RE: RAI for Title V Permit Application
Gerdeau Ameristeel, Jacksonville Steel Mill
Title V Air Permit No. 0310157-006-AV

This letter provides responses to the Department's Response for Information (RAI) letter of April 22, 2004.

**COMPLIANCE ASSURANCE MONITORING PLAN
FOR
GERDAU AMERISTEEL
JACKSONVILLE STEEL MILL
BALDWIN, FLORIDA**

Figure 1. CAM Correlation Baghouse 1-2

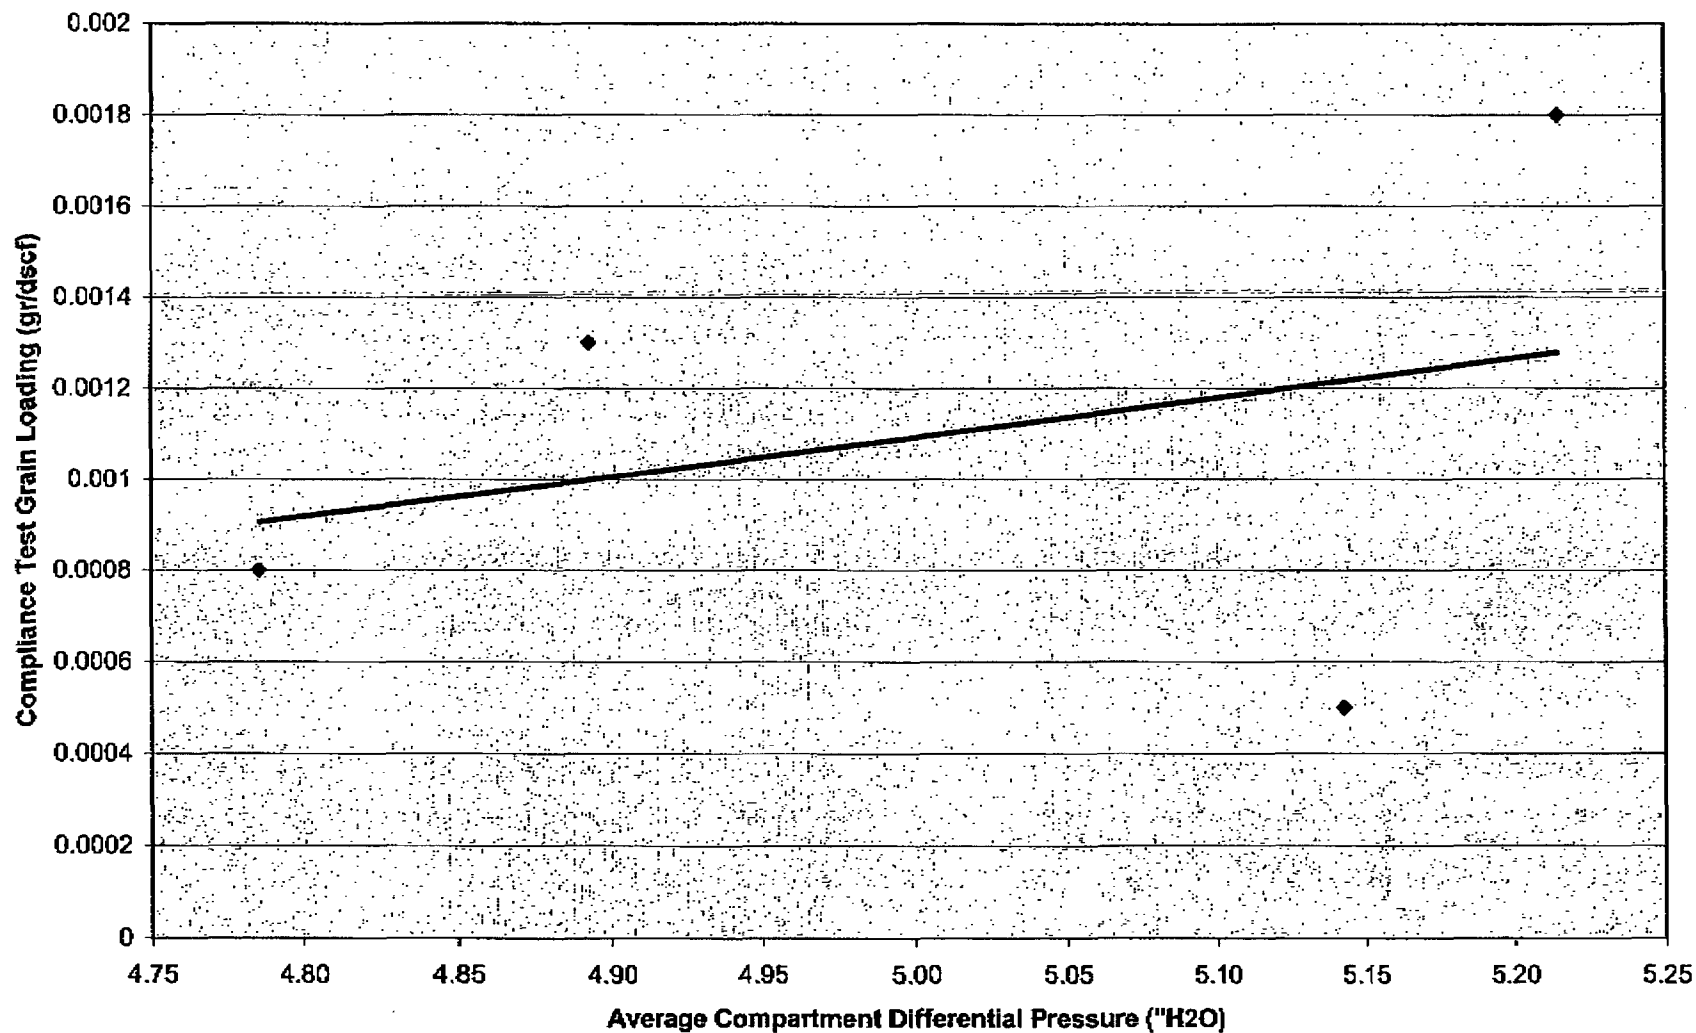
The Department has determined that the CAM Plan submitted by Gerdau Ameristeel does not provide sufficient compliance assurance monitoring. The selection of pressure differential as an indicator is an appropriate indicator for particulate matter (PM) emissions. Pressure differential should be expressed as a range comprised of upper and lower limits. The CAM Plan submitted identifies the upper limit only. Please provide the lower limit and required actions taken for such an occurrence. The Department requests that an additional indicator is provided because this emission unit has post controlled PM potential emissions of greater 60 tons per year (TPY). Other indicators for this emission unit that could be monitored include visible emissions, inspection/maintenance, and/or auxiliary equipment performance.

Response 1: Indicator No. 1 has been revised to include both a lower and upper limit. In addition, as requested a second indicator has been included. Monitoring fan amps is a requirement of 40 CFR 60.274a as an indicator of volumetric flow rate. As an indicator of volumetric flow rate, fan amps will provide assurance of proper operation of each baghouse and is submitted as a secondary indicator for CAM. See the attached revised CAM Plan for these revisions

Compliance test data for the last 5 years was analyzed to determine if a correlation could be made for particulate grain loading and baghouse pressure drop. Grain loading was plotted versus baghouse pressure drop and the results can be seen in Figures 1 and 2. As shown, there is almost no correlation between grain loading and baghouse pressure. Based on the correlation and nature of the data, more test data will not result in a better correlation.
